**Attachment 1 - Site Location Map - 210 Alexandra Parade East, Clifton Hill**

Attachment 2 - Proposed floor plans, Elevations, Perspectives and Shadow Diagrams - 210 Alexandra Parade East, Clifton Hill

**Attachment 3 - Urban Design comments**

**TO: Patrick Sutton**  
**FROM: David Pryor**  
**DATE: 11 December 2017**  
**SUBJECT: 210 Alexandra Parade East, Clifton Hill**  
**APPLICATION NO: PLN17/0693**  
**DESCRIPTION: Construction of a six-storey residential building**

**PERSPECTIVES - SOUTH VIEW FROM ALEXANDRA PDE EAST**  
SCALE: NTS  
DRAWN: PFC, PHL, PS  
CHECKED: PHL, PS

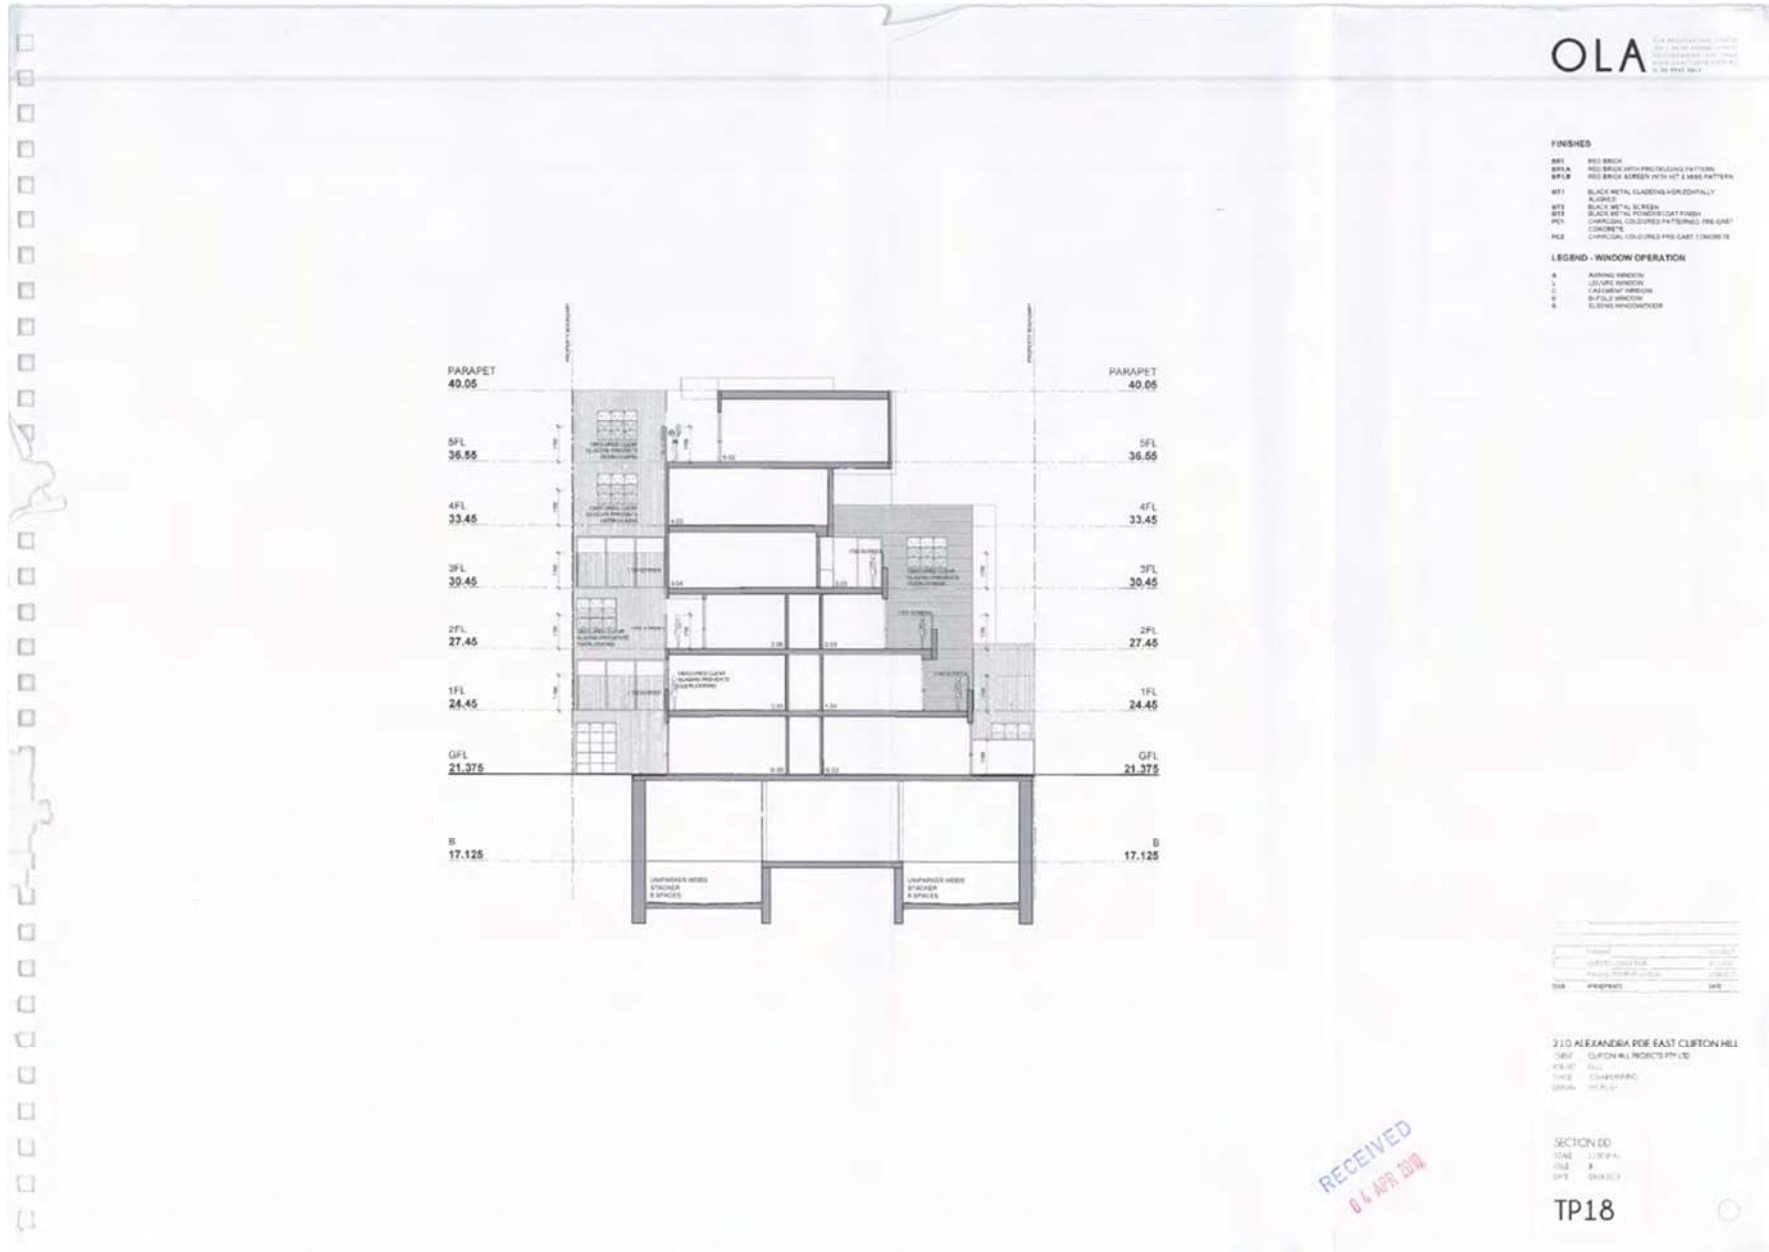
Reduction of 900mm to parapet height and introduction of setback along Alexandra Parade East south façade on levels 4 & 5.

Integrated design solution with upper form of building to tie in with the eastern façade's original black metal vertical cladding. Simplification of building colours and material palette.
